**ENGINE REBUILDERS ASSOCIATION**  
**Oil Pump Replacement Caution on**  
**2004-2008 Suzuki 2.0L Engines**

The AREA Technical Committee offers the following information regarding a caution on oil pump replacement for 2004-08 Suzuki 2.0L engines. New original equipment oil pumps require a relocation of the engine oil pressure switch during the replacement procedures.

Figure 1. Left Arrow Gallery Plug, Right Original Switch Location

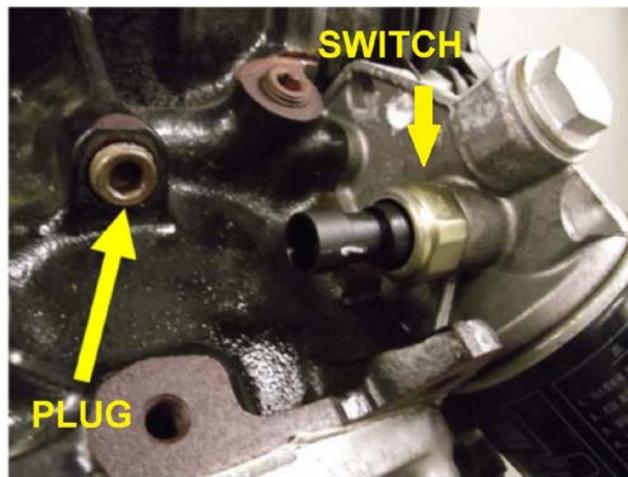
The original design of the oiling system on this engine has the oil pressure switch located in the external portion of the oil pump assembly as shown in Figure 1. When a new original equipment pump is being replaced it is important to note, New Suzuki replacement oil pumps are supplied with a threaded plug installed into the previously used oil pressure switch port. This plug is very difficult to remove without damaging the new oil pump by causing distortion and thread damage. The plug should be left undisturbed as viewed in Figure 2.

New oil pump replacement also requires re-location of the oil pressure switch to the block header, a short distance away as show in Figure 1.

To relocate the existing switch or a new switch Part #37820-86Z02, obtain a new gasket and install into the block, torquing it to 30 FT/LBS. Connect the existing wire harness to the oil pressure switch. No modifications are required to the harness length or connector for the relocation of the switch.
